Rezoning Transportation Analysis

Petition Number: Insert Zoning Petition #2021-264

Date	Description
04-28-22	First Review (PDM)
5-25-22	Second Review (TM)

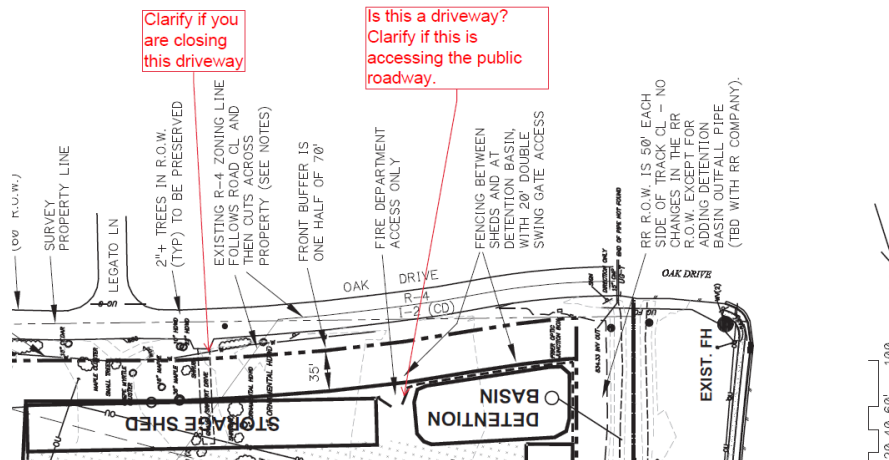
7. **Outstanding Comment from 04.28.22:** Site plan and conditional note(s) revisions are needed to clarify how the proposed access point on Oak Drive will be restricted to Fire Department access only. In addition, revise site plan to show how the driveway will access the public road. Coordinate with Charlotte FIRE to determine if this access needs to meet fire apparatus road requirements.
8. **Outstanding Comment from 04.28.22:** Site plan and conditional note(s) revisions are needed to clarify what is happening to the existing gravel driveway on Oak Drive that accesses the site. If the driveway will be closed as part of the project, add a callout to remove the driveway.
